AGENDA CITY OF CEDAR FALLS, IOWA PLANNING AND ZONING COMMISSION MEETING TUESDAY, NOVEMBER 21, 2023 5:30 PM AT CITY HALL, 220 CLAY STREET

SUBJECT: Rezoning Request for property located North of Aldrich Elementary School and

South of W. Greenhill Road (RZ23-003) Land Use Map Amendment (LU23-002)

SUBJECT: Property improvements in the College Hill Neighborhood Overlay District

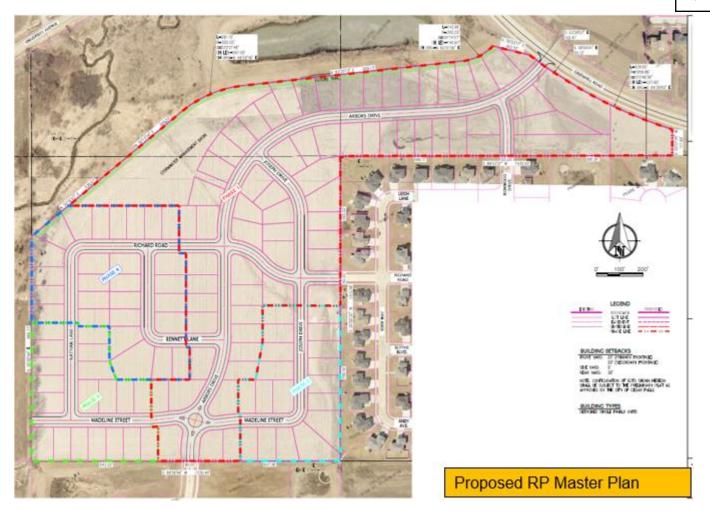
Staff recommends changing the Future Land Use Map designation to "Low Density Residential Use" and to adjust the "Greenways & Floodplain Use" to align better with the stream corridor with enough space for a future public trail. See below image for more reference. The exact area needed for the trail could be delineated on the preliminary plat for the Panther West development based on the topography and specific plans for the stormwater management. Maintaining the greenway along the edge of this development would ensure there is an adequate buffer from the floodplain area (north of subject property), which would align with the intent of the City's Comprehensive Plan. The developer agrees with staff's recommendation.

DEVELOPMENT R-P MASTER PLAN

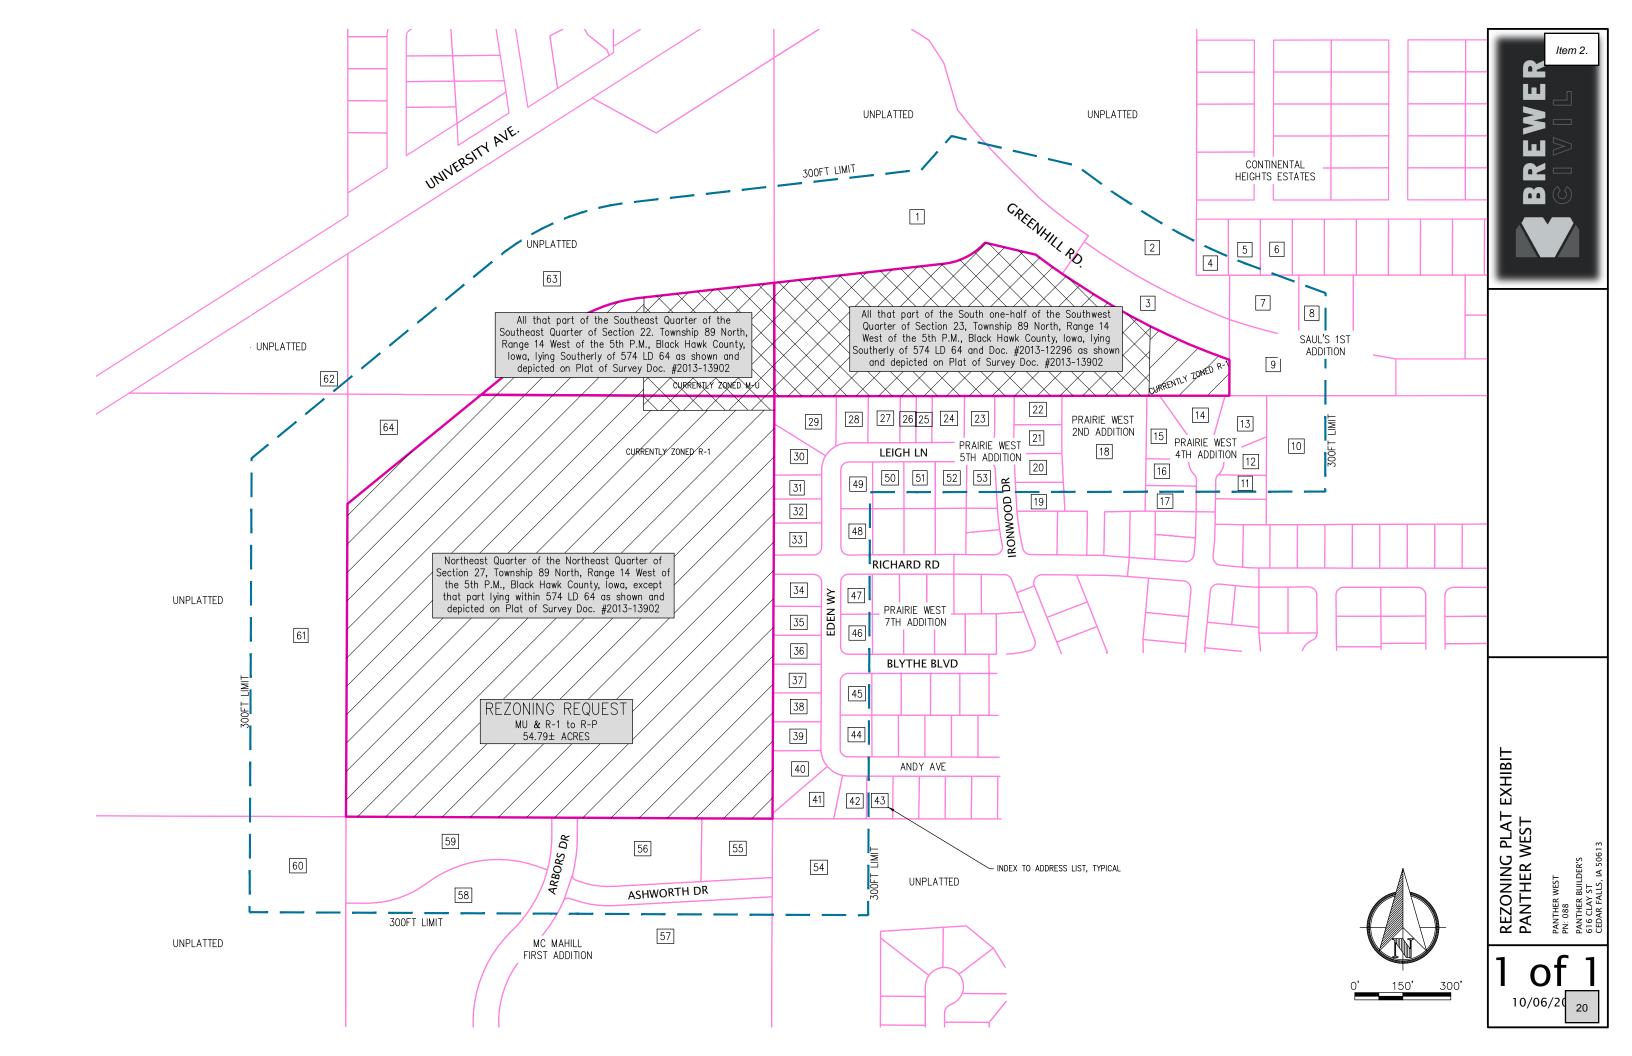
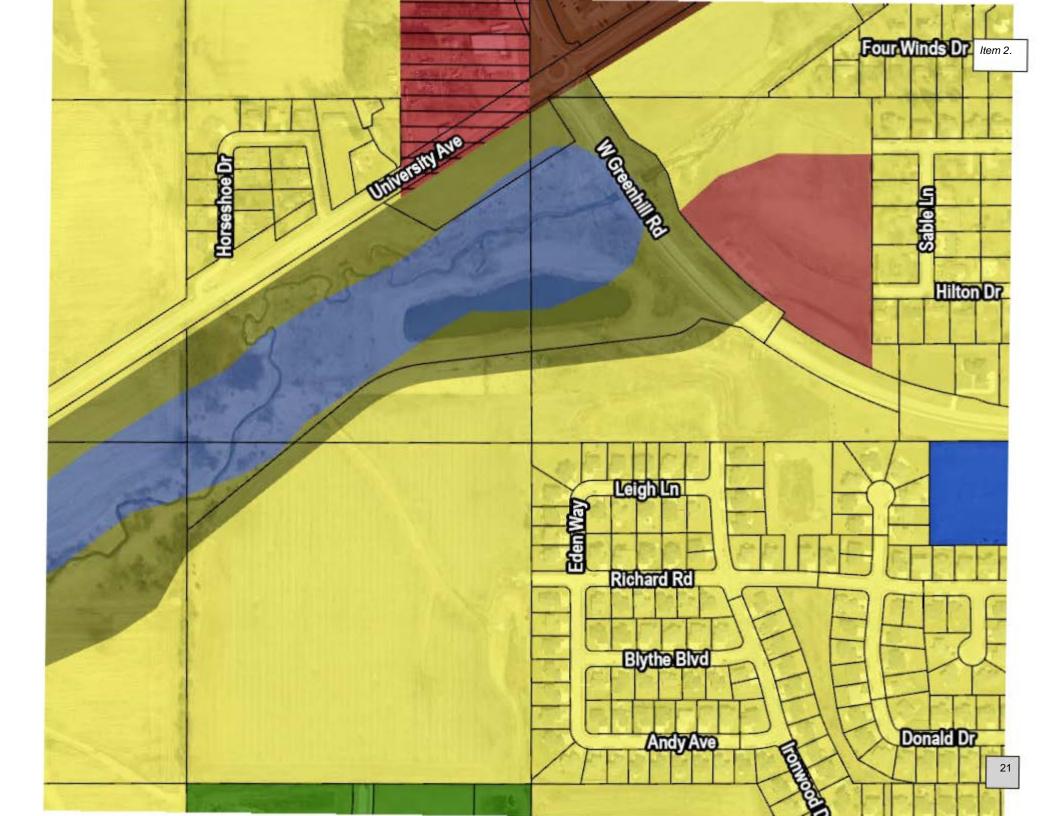
The applicant proposes an RP Master Plan that restricts the development to detached single family dwellings only, which will be developed in four phases. Staff notes that the lot lines shown on the RP Master Plan are for conceptual purposes only, as the exact configuration will be established with the preliminary plat once exact size and location of stormwater facilities, easements and necessary infrastructure is determined.

The street layout is one of the most important aspects of the proposed master plan as it should demonstrate a well-connected street pattern with multiple, direct routes between neighborhood destinations with a phasing plan that ensures that critical street routes are completed first to reduce traffic congestion, encourage safe walking and biking, improve emergency access and response times, and allow for the timely provision of essential infrastructure. The Master Plan proposed by the applicant is shown below.

The proposed RP Master Plan illustrates that Arbors Drive will be extended northward to W. Greenhill Road. Richard Road will be extended westward into the proposed development and Ironwood Drive will be extended northward to connect to W. Greenhill Road. All these street extensions would allow both the proposed development and the adjacent development to east and south of the subject property with alternative routes to and from the development, which will distribute the traffic in the neighborhood and more importantly provide needed street connections to navigate between the subdivisions. Staff notes that the proposed extension of streets as noted above will address the missing critical connections for the surrounding land uses, provide distribution of traffic, and provide much needed accessibility to Aldrich Elementary School.

The proposed RP Master plan also shows that the Madeline Street will be extended westward from the Arbors Drive, providing a connection opportunity for future development of the area to the west of the subject property, with all city services being stubbed to the western boundary of the subject property. All these street extensions/connections are likely to take place as per the proposed phasing that is indicated on the submitted RP Master Plan for the subject property.

The proposed RP Master Plan indicates that the development will occur in four phases. With master planned development, it is important to think about phasing to ensure that critical street connections occur first to reduce traffic congestion and provide for the distribution of traffic to

The applicant's original proposal for phasing addressed two critical street connections in Phase 1 of the development: the extension of Arbors Drive and Ironwood Drive. Completion of these streets will create additional routes to Aldrich Elementary School and to other community destinations for area residents. However, at the November 8th Commission meeting, staff recommended adding the extension of Richard Road and all lots north of Richard Road in Phase 1 of the project. The extension of Richard Road to Arbors Drive will allow another route from the neighborhood to the east to the school. Connecting Richard Road in Phase 1 of the project would allow distribution of the traffic within the neighborhood and allow the possibility for students/parents within the neighborhood to walk/bike to the school.

The developer has now revised the phasing plan as per staff's recommendation as shown above. The updated RP Master Plan Amendment exhibit is attached in the packet for more reference. The applicant's proposed phasing plan now addresses three critical street connections in Phase 1 of the development: the extension of Arbors Drive, Richard Road, and Ironwood Drive as noted above in the staff report.

Figure 3 - Site Plan

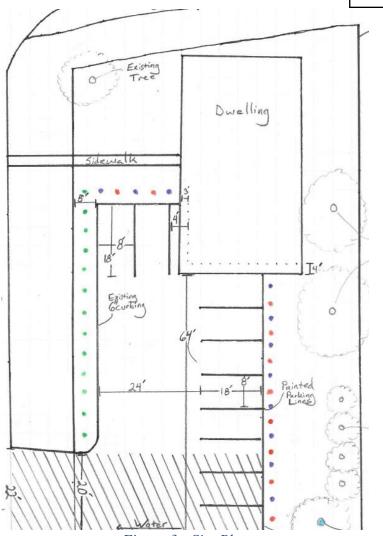
Neighborhood Character: Overall, the proposed changes improve the existing condition
of the parking area. This includes the establishment of green space where paving was
not necessary. The proposed parking are is similar to other parking areas found in the
College Hill Neighborhood Overlay District. Also, the proposed plan complies with
landscaping provisions now applicable with the proposed changes.

The proposal reflects staff's recommendations in regard to stormwater runoff that may have otherwise been a nuissance, and the intends to comply with all potential code items that need to be addressed to make this property code compliant, including other conditions of their rental permit identified through the rental review process. **Staff's assessment is that the proposed site plan maintains and in many ways improves neighborhood character.**

2. Minimum on-site parking requirements: The College Hill Neighborhood Overlay District requires one parking stall per bedroom. The required dimension of one parking stall for residential uses is 8 feet by 18 feet. The applicant is proposing 10 parking stalls with those dimensions. The proposed parking quantity appears to be the highest practical

- 3. Parking lot standards: A parking lot is defined as an area designated for parking three or more vehicles. The parking lot must maintain a five-foot minimum setback from property lines, an aisle that accommodates two-way traffic, a continuous curb around the parking area, and adhere to a plan for how the stormwater will be managed. The parking area must also maintain a four-foot setback from the house. The proposed site plan layout meets all applicable parking lot standards.

- 4. Open space/ landscaping requirements: This criterion regulates parking areas and required green spaces. For rear yard coverage, a multi-unit dwelling in the R-2 zoning district can have maximum rear yard coverage up to 50%. As provided for in the parking code standards, the Planning and Zoning Commission and City Council may approve up to an additional 5% coverage if the situation warrants. For reference, the existing parking area prior to removal of the garage was at about 65% rear yard coverage. The petitioner is proposing a parking area that covers 53.3% of the rear yard so is requesting approval from P&Z and Council to be able to exceed the 50% standard. Also, the proposed plan shows required screening shrubs around the entire parking area, as required. Staff finds that the proposal meets the intent of the open space and landscape requirements and the proposed changes will improve the existing condition of the parking area by reducing the rear yard parking lot coverage by approximately 12%.
